Cultural Heritage Board Certificate of Appropriateness (CR) Staff Report

I. CASE NUMBER(S): P12-0232

- 1) **Proposal:** Consideration of a Certificate of Appropriateness to approve a previously poured 450 square foot concrete slab for parking in the street side yard setback of an existing single family residence located in the Palm Heights Historic District and the R-1-7000 zone at the southwest corner of Brockton Avenue and Merrill Avenue.
- 2) **Location:** 6361 Brockton Avenue
- 3) **Applicant:** Craig Celse
- 4) **Case Planner:** Teri Delcamp, Historic Preservation Senior Planner
(951) 826-2117
tdelcamp@riversideca.gov

P12-0232, Exhibit 3 - Project Plan

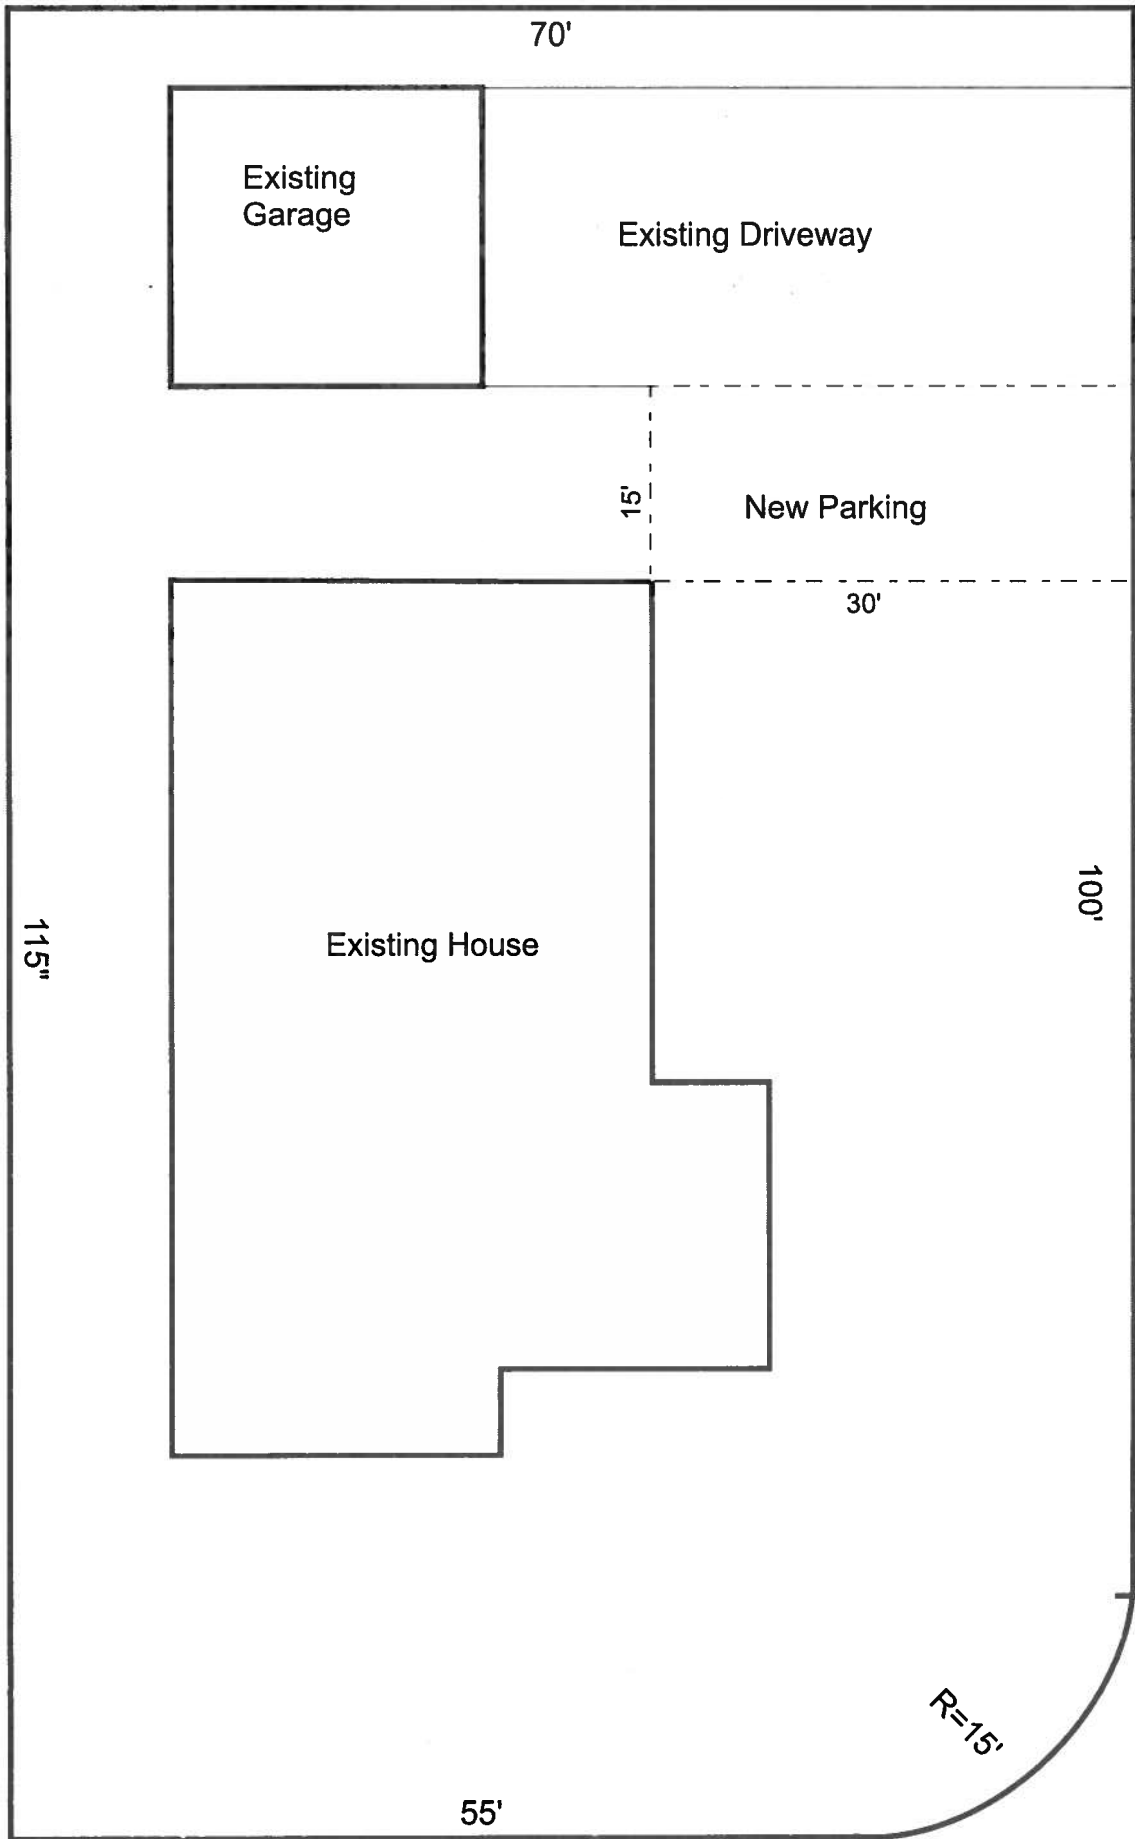
The project proposes approval of an existing concrete slab that was poured within the street side yard setback by the applicant without approval of a Certificate of Appropriateness. The slab extends to the left side of the property’s driveway, and is approximately 15’ wide by 30’ long. The applicant poured the slab in an attempt to address a Code Enforcement case regarding dead grass in the yard facing Merrill Avenue. The property has little on-street parking available since the frontages along Merrill and Brockton Avenues are red-curbed. Cars had been parked on the grass next to the driveway, killing the grass. The applicant claims that Code Enforcement discussed options with him, including the replacement of the dead grass with concrete. The applicant did not consult with Planning before proceeding with this remedy, so the Certificate of Appropriateness is being requested after-the-fact.

The PHHD Design Guidelines note that one of the character-defining features of the Historic District is its narrow driveways. Accordingly, the Guidelines call for driveways to be narrow. Several existing driveways in the District are as narrow as 10’ but are typically 12’ wide. The Guidelines also state that side yards “should not be covered with paving...to turn the...side yard into additional parking.” The property already had what appears to be a 1½ car garage with a 15’ wide driveway approach, which is already wider than the majority of residential driveways along Merrill (the attached site plan implies that the existing driveway was 20’ wide, but it is only about 15’ wide). The additional 15’ wide concrete slab expands the driveway to twice the existing driveway width and is not consistent with the PHHD Design Guidelines.

The project does not meet any of the above requirements. The expansion of the existing driveway with a 450 square foot concrete slab within the landscape street side yard setback does not comply with Section 19.580.050.I of Title 19. Concrete was poured on the opposite side of the driveway within the street side yard and does not comply with Sections 19.580.070.A.2 and 19.580.070.A.3 of Title 19.

1. Prior to commencement of work, the applicant shall revise the project and submit plans for the approval of CHB staff to show:
 - a. The proposed barrier within a three foot wide planter between the slab and the sidewalk modified to be six feet in height in materials consistent with the architectural style and materials of the historic home, revised to be either:
 - i. Solid wood; or
 - ii. A combination of solid wood or stuccoed masonry and open woodwork at the top half; or
 - iii. The sufficient number, size and species of hedge plantings that will achieve the required six foot screening height within one year of planting.
 - b. The species, size and number of plants within the planter, along with proposed groundcover if not a hedge, and method of irrigation.
2. The applicant shall complete the approved modifications to the site within 60 days after the date of this approval.
